In the matter of the direct referral of applications for resource consent and notices of requirement under sections 87G and 198E of the Act for the Ōtaki to North of Levin Project

**STATEMENT OF REBUTTAL EVIDENCE OF PHILLIP JEREMY PEET ON
BEHALF OF WAKA KOTAHI NZ TRANSPORT AGENCY**

Dated 10 October 2023

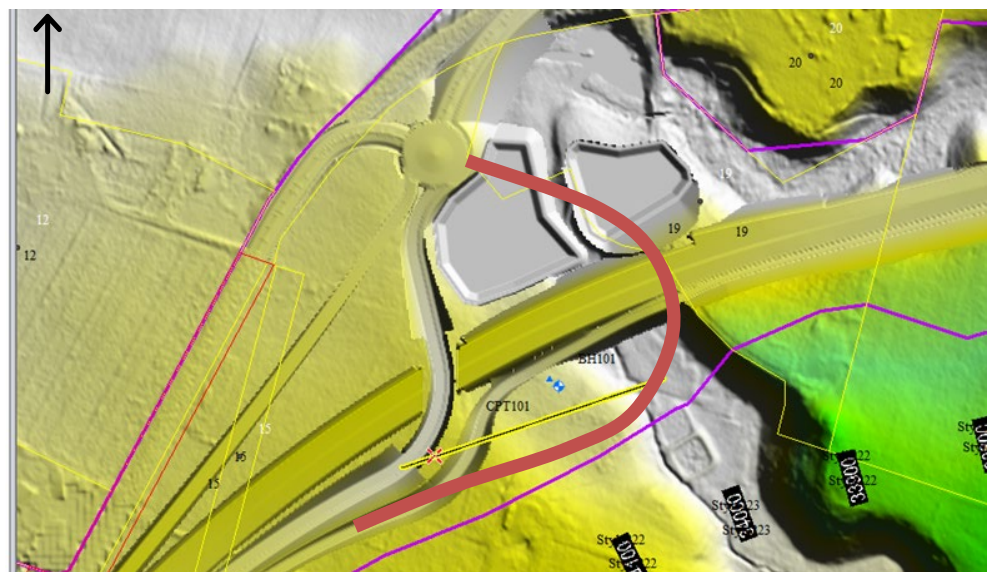
13. I have read both Mr Dunlop's and Mr Mallon's evidence and have considered their proposed design ideas and alterations to conditions.
14. In summary, I acknowledge that an option which provides both a parallel arterial and local connectivity would provide additional benefit. However, I am still of the opinion that something with this functionality cannot be created without significant cost and adverse effects.
15. Concerns raised by Mr Dunlop and Mr Mallon in regard to resilience, suitability of the alternative route and interchange spacing have already been covered in my Evidence.¹ My view remains that the Project will increase the resilience of this highway route and will not create additional issues.

Furthermore, the resilience concerns identified by Mr Dunlop and Mr Mallon would only eventuate if a crash were to happen in the 4km section of highway between Ōtaki and Taylors Road. The probability of that occurring with any regularity is very low given this is a 5-star rated highway. The probability of a crash occurring on this section does not increase as a consequence of the Ō2NL Project, in fact it decreases as it will remove the current northbound merge where the highway reduces from two lanes to one (the Ō2NL project will deliver two continuous lanes in this location)..

16. Whilst the alternative route is not ideal, it is functional and other alternative routes will also exist, as they do currently, east of the new highway. Interchange spacing has been assessed by experts in the design team and Waka Kotahi and it is not considered to be an issue.

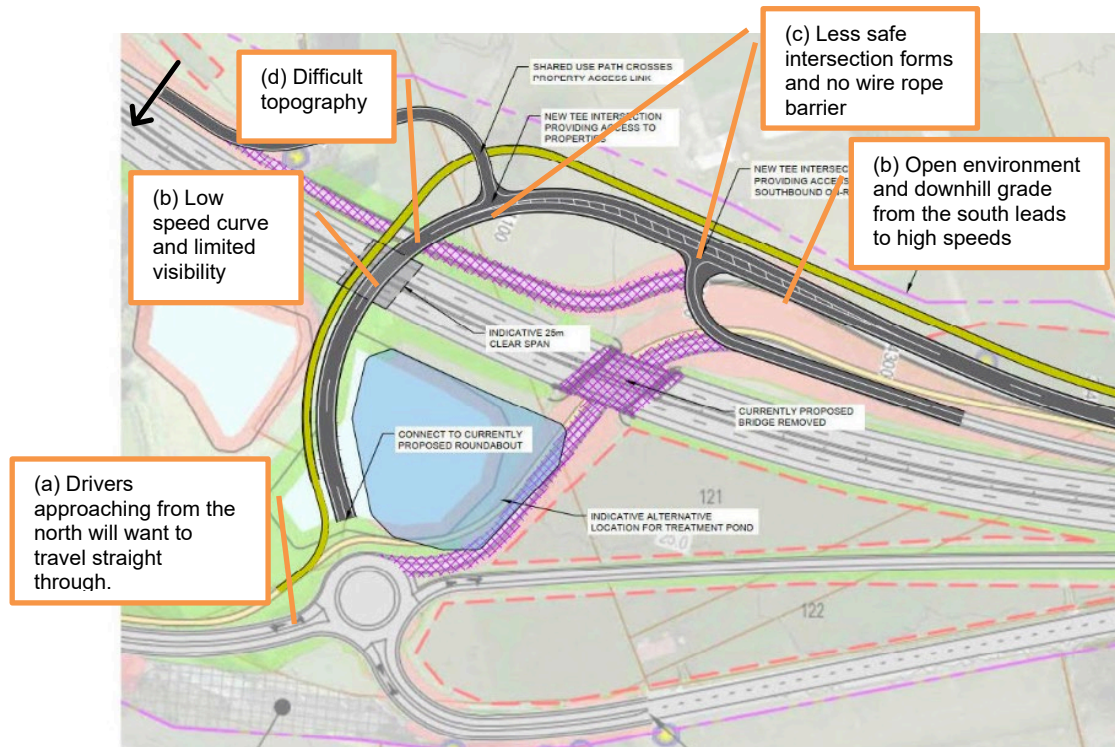
17. The interchange layout identified by Mr Dunlop and his colleague Mr Thornton is very similar to one of the concept options identified by the design team earlier in the Project development process. This option was rejected for a number of reasons including topography, safety, and the surrounding environment.

18. In terms of topography, this area is in rolling terrain which includes deep gully systems. The alignment of the proposed parallel arterial in this option would need to traverse a gully which is 15m deep. This then creates significant engineering, construction and environmental challenges. This stark change in ground level can be seen in the image below, with grey being low ground, yellows and greens being high ground. The red line shows the approximate location of Mr Dunlop's suggested new two way arterial.

19. Mr Dunlop states that his option was not developed in 3D. That would explain the lack of consideration of this 15m deep gully which traverses through the site at this location and its potential implications. I expect the earthwork and drainage impacts of this link would lead to increases in cost, increased difficulty and a significantly increased footprint that could extend outside the proposed designation.

20. I also have significant safety concerns with Mr Dunlop's option including:
 - (a) The roundabout layout would not be easily readable to drivers. Approaching on the old highway from the north, drivers would need to turn left at the roundabout to get onto the new highway or to enter Ōtaki. This is counter intuitive as both those destinations are straight ahead. It is usual for arterial routes to proceed straight through such intersections and if drivers attempted the expected straight-through movement in this location, they would be driving up an off-ramp which could lead to a serious crash on the new highway.

- (b) The posted speed of 50km will be challenging to enforce with the lack of side friction and rural environment. Whilst southbound traffic will be coming from a slow-speed roundabout, northbound traffic will have a long straight and will also be at a significant downhill grade which will lead to high speeds heading into a low-speed curve with intersections and limited visibility.

- (c) T-intersections are proposed with both the southbound on-ramp and the property access to the north. In addition to these not being as safe as roundabouts (and hence having an increased risk of high severity crashes), they also prohibit wire rope median barriers which prevent head on crashes.

- (d) The combination of vertical and horizontal geometry is likely to create further challenges and safety issues that will only be able to be determined after 3D design is undertaken.

22. Based on the above, I would not support a condition that states that a two-way local arterial connection could be developed in general accordance with the layout proposed by Mr Dunlop.
